**ASHLAND PLANNING DEPARTMENT
PRE-APPLICATION CONFERENCE
COMMENT SHEET**
June 5, 2024

SITE: Kestrel Park Areas 4-7
APPLICANT: Taylor/Knox
REQUEST: Outline Plan for 4 lots
Exceptions (?)

Figure 18.3.5.100.C.2. Neighborhood Access Street

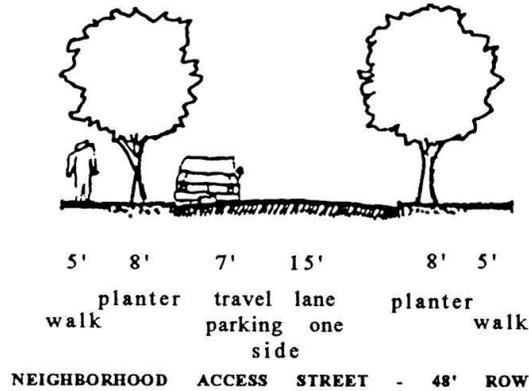
- The development complies with the street standards.*
- The North Mountain Neighborhood Master Plan has overlay-specific street standards which are detailed in AMC 18.3.5. Nandina, Stoneridge, Patton and Nestbox Way

within the parent subdivision are all “Neighborhood Access Streets” and would be subject to the standard cross-section below, except as modified with the parent subdivision approval (which included some street specific conditions):

The parent parcel’s Outline Plan approval noted that where any sidewalk improvements to meet standards were outside of the right-of-way, easements or additional dedications would be required to provide the full standard cross-section improvements.

The Outline Plan approval also noted specifically that curbside sidewalk installation in Areas 5 & 6 would require exceptions and did not – *at least at that stage* – appear to be merited.

As noted in the Fire Department comments, there will need to be further discussions with Fire relative to aerial truck access requirements as they relate to street standards.

If street improvements and sidewalks will be required prior to plat as is typical with a Performance Standards Subdivision, how/when/where will curb cuts be provided?

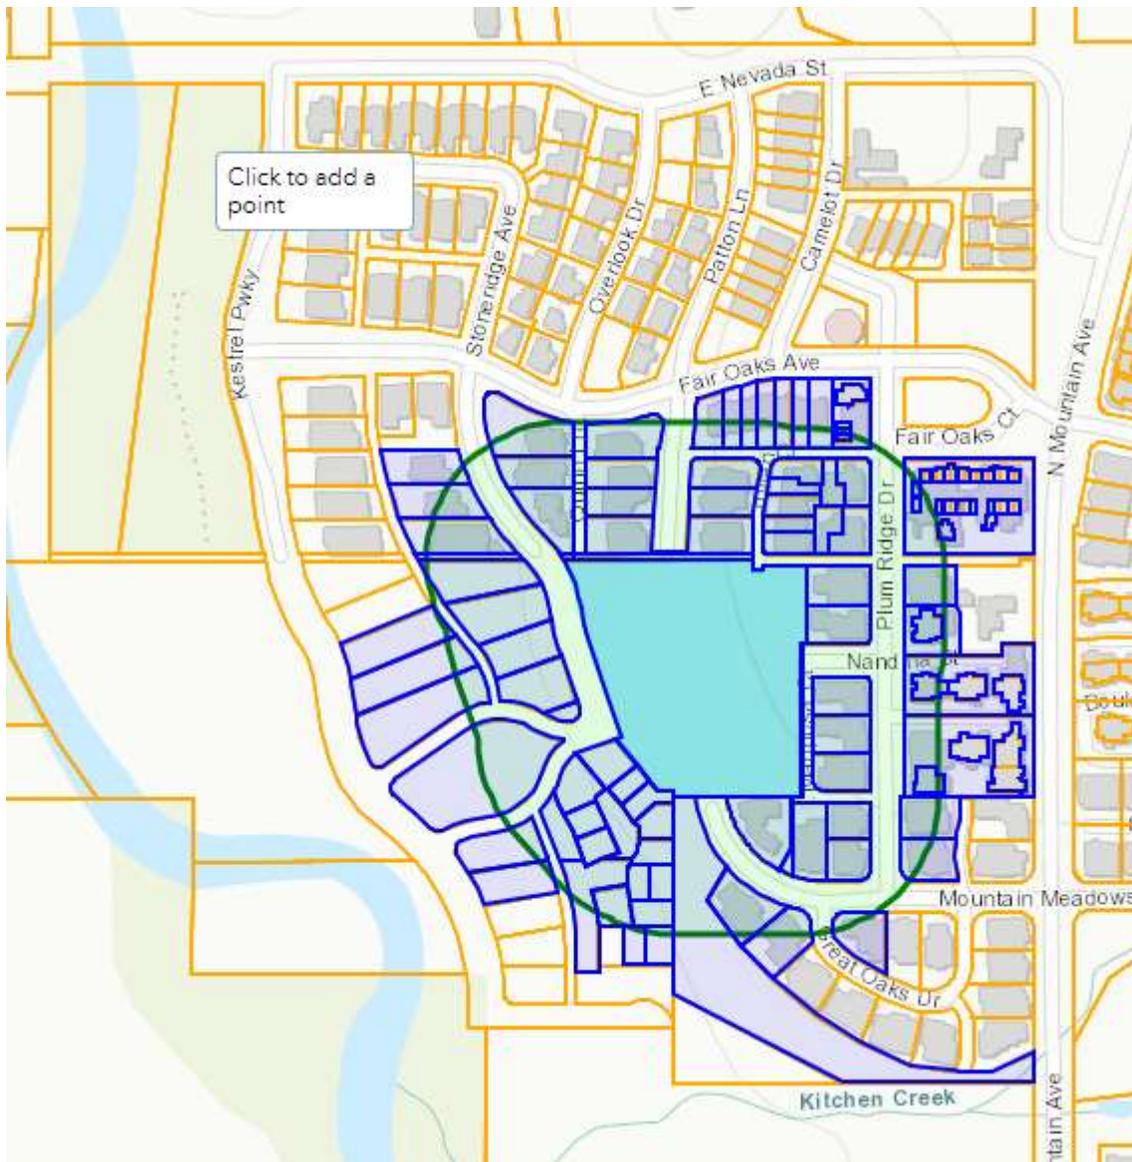
- Alleys were discussed at Outline Plan and the Commission determined that they needed to be installed to the full NMNP standard cross-section below, **including the full four-foot width shoulders:**
